**SYDNEY CENTRAL CITY PLANNING PANEL
COUNCIL ASSESSMENT REPORT**

| DA Number | DA/61/2018 |
| Proposed Development | 21 storey mixed use building comprising 2 – 3 storey podium containing 5 retail tenancies and 18 storeys of shop-top housing above containing 130 apartments (46 x 1 bed, 70 x 2 bed and 14 x 3 bed) over 4 storeys of basement car parking; public through-site link; and demolition of existing buildings. |
| Street Address | 48-54 Beecroft Road and 52-54 Rawson Street, EPPING NSW 2121 (Lot 2 DP 592094, Lot 1 DP 541808, Lot 1 DP 592094, Lot 2 DP541808, Lot 4 DP 541960, Lot A DP 325036 and Lot 3 DP 541960) |

Figure 13. Example configuration of storage cages in parking area.

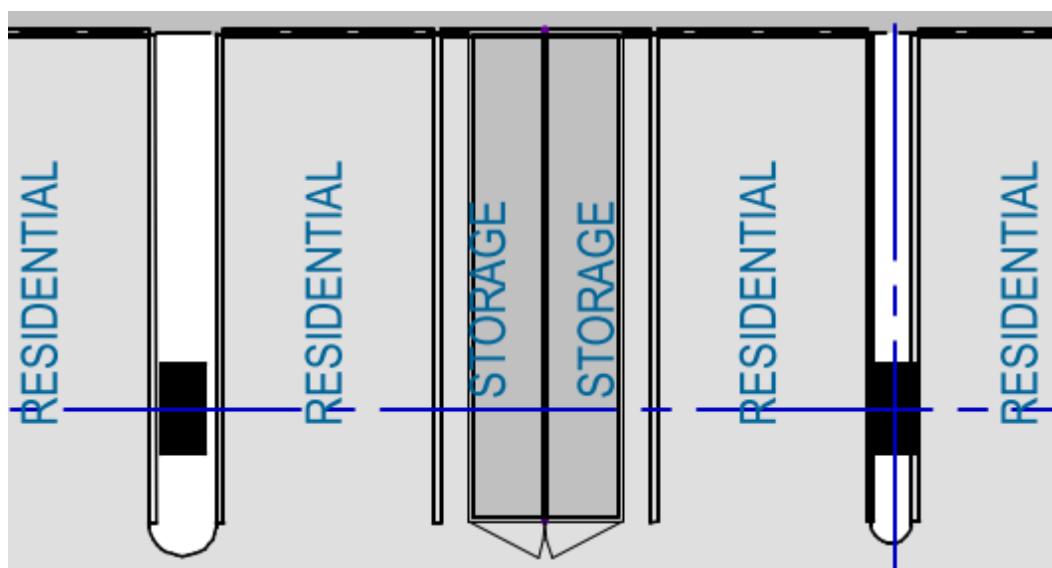
The proposal nominally provides the minimum parking required by the SEPP. However, the applicant has provided storage cages within areas the dimension of car parking spaces (see Figure 13 below).

These cages would easily be removable to provide 17 additional parking spaces in the future. The level of storage, not including these cages, is already in excess of that which is required by the ADG. As no further parking is considered appropriate, these additional potential car parking spaces, along with the inadequate Green Travel Plan discussed above, are considered to be reason to refuse the application.
